Subject: Reply TIMCO-TCB/Request for additional info of Job#1098TC10
FCC ID: NM8PC49100

Antenna Distance

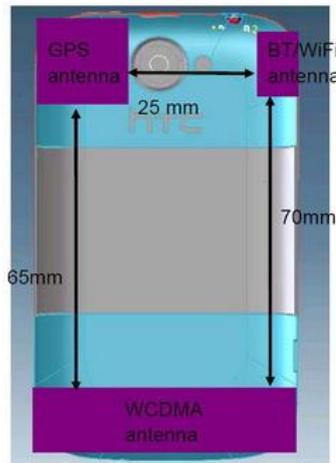
1. Please clarify if any simultaneous Tx exists and with which antenna: and what are the head and body SAR for each combination/mode it is unclear what modes and configurations (head or body etc.) these SAR represent. In general, head is compared to head and body to body to figure out simultaneous transmission.

- 1. BT & WLAN are not simultaneous transmission**
- 2. GSM & WLAN are simultaneous transmission**
- 3. GSM & BT are simultaneous transmission**

Antenna Separation- GSM to WLAN=7cm >5cm, the simultaneous SAR is not required

Antenna Separation- GSM to BT=7cm >5cm, the simultaneous SAR is not required
